MEMO

Subject:
Ford Livonia Transmission Plant - Offsite VI Study

Your comments and our responses are presented below:

Figure 1 – Off-site Vapor Intrusion Assessment Vinyl Chloride in Soil Vapor

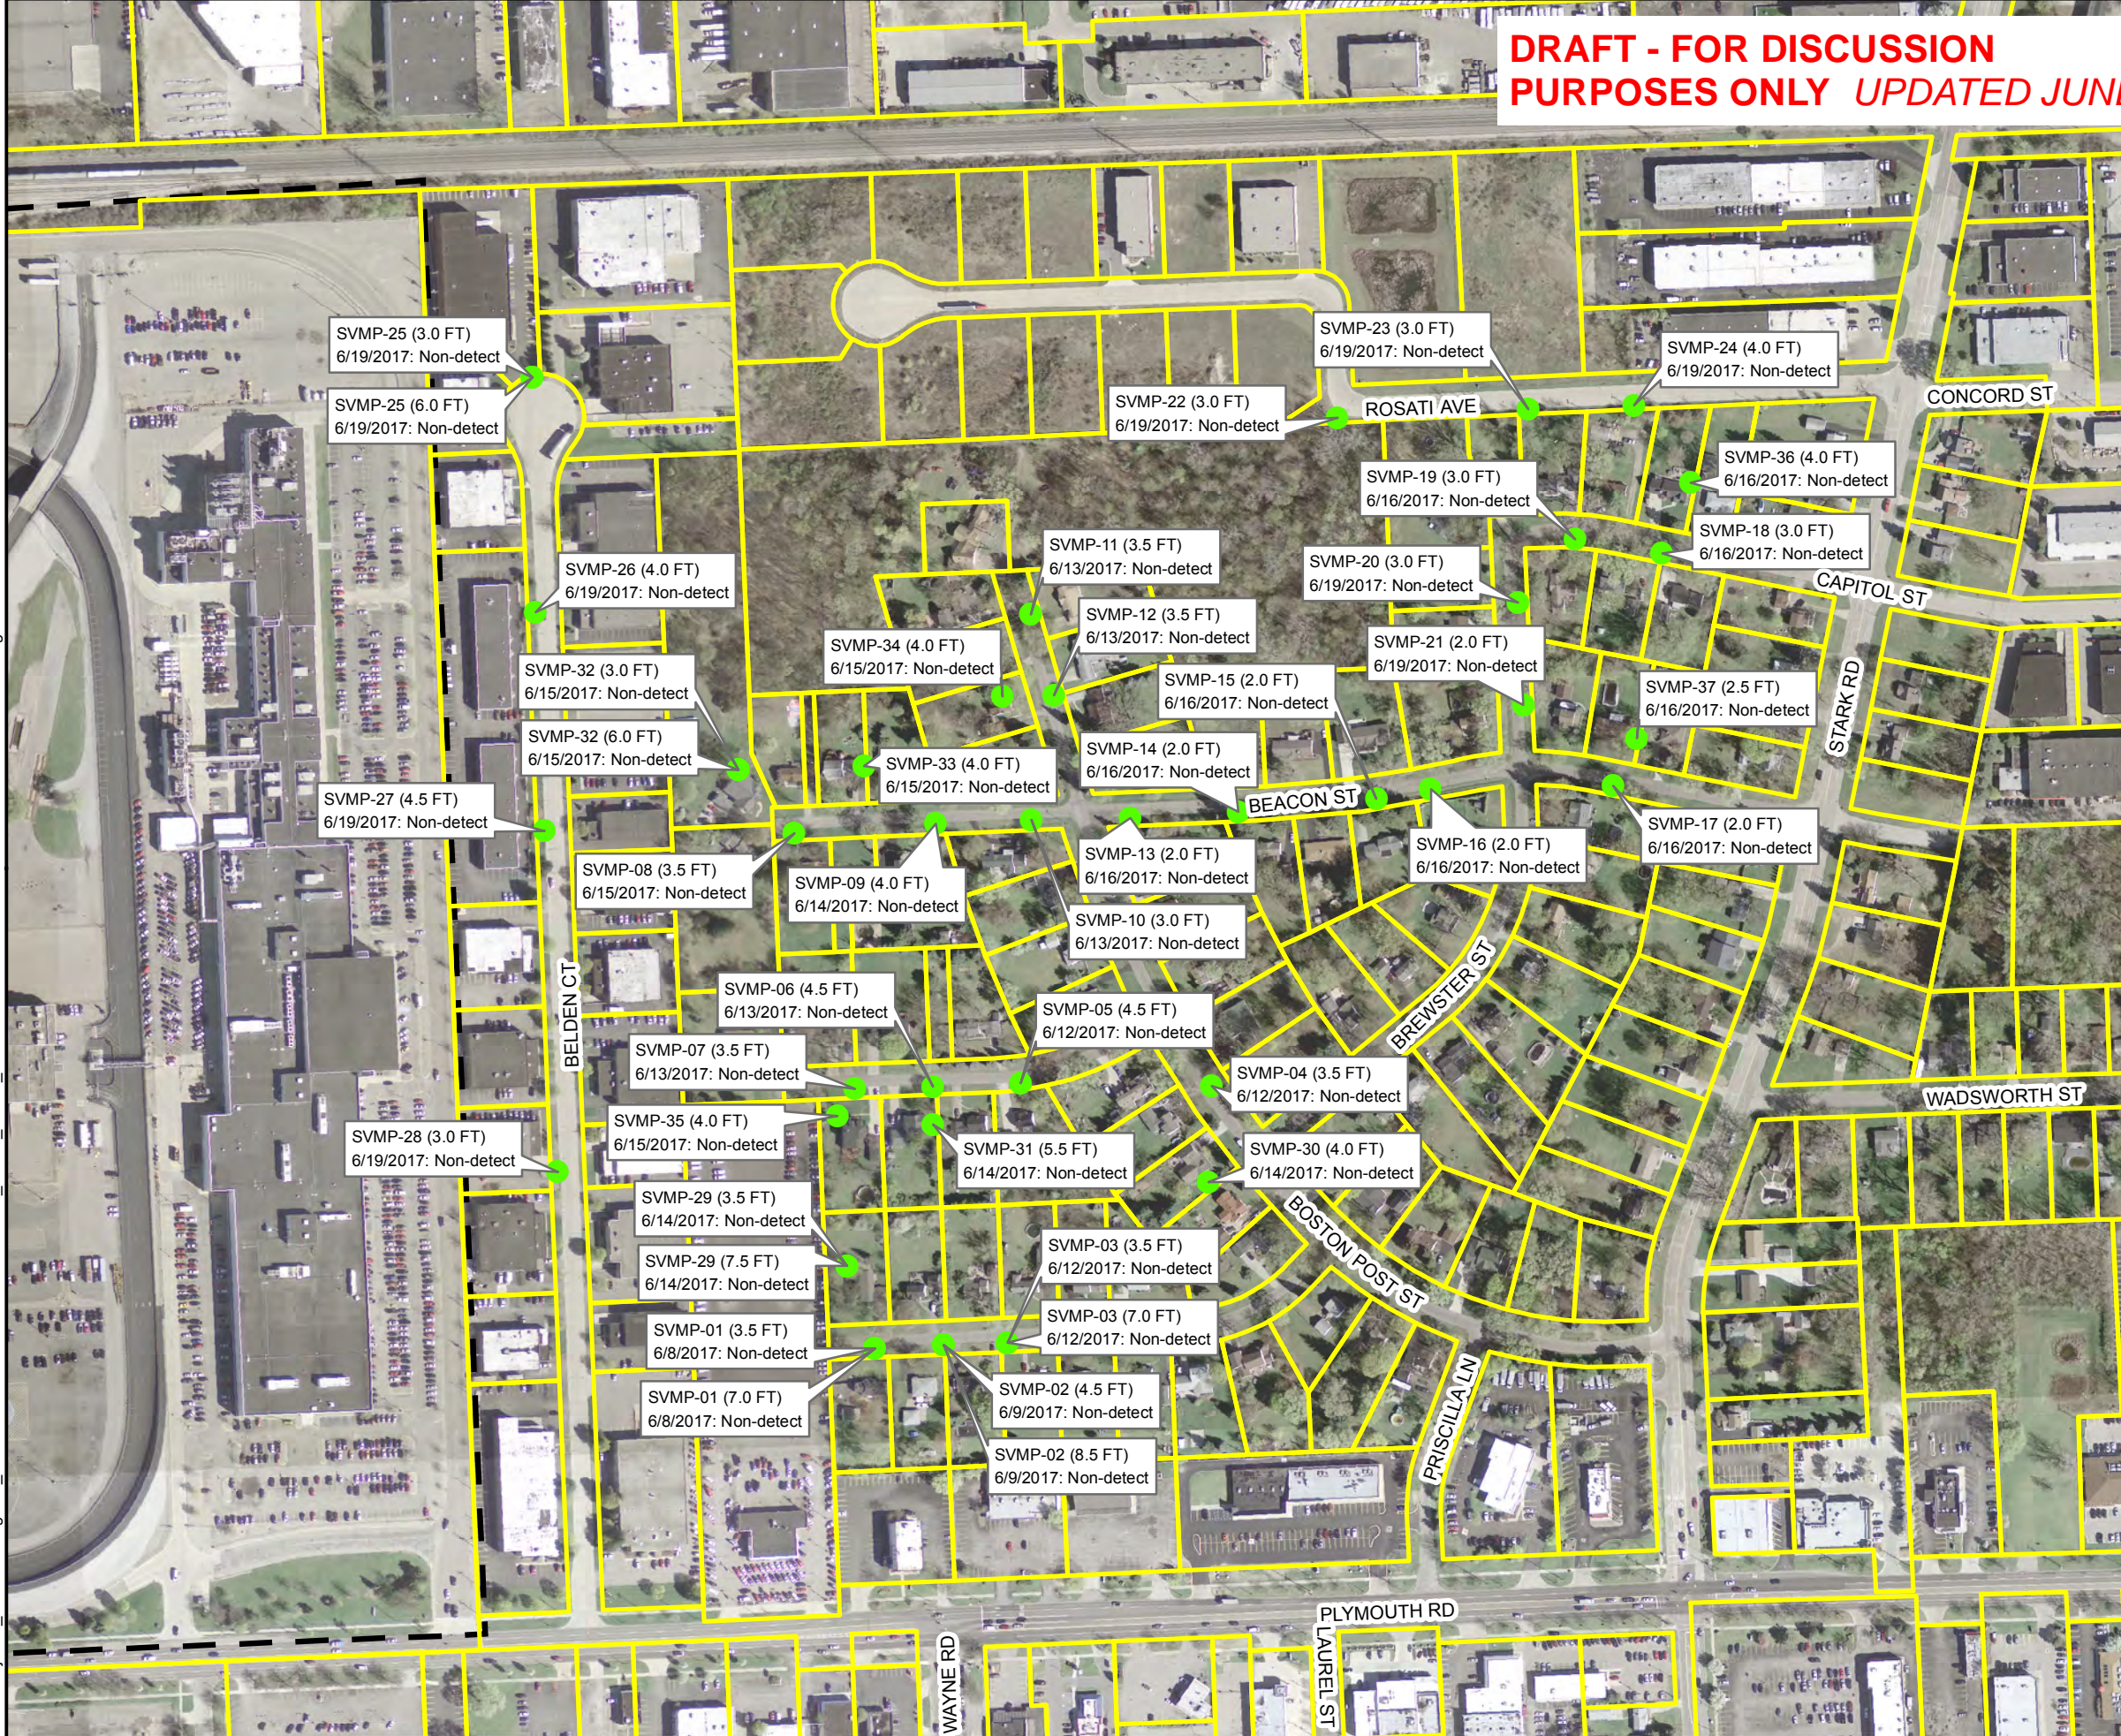
Ford installed 43 temporary soil vapor monitoring points east of the Livonia Transmission Plant. As shown on Attachment 1: Off-Site Vapor Intrusion Assessment Figures 1 and 2, vinyl chloride and trichloroethene results are all below MDEQ action levels. To provide additional data, Ford also analyzed groundwater beneath the soil vapor monitoring points located on residential properties. As shown on Attachment 1: Off-Site Vapor Intrusion Assessment Figures 3 and 4, the results are consistent with groundwater monitoring for the area and indicate the extent of vinyl chloride in groundwater has successfully been defined and there is no impact to drinking water in the area.
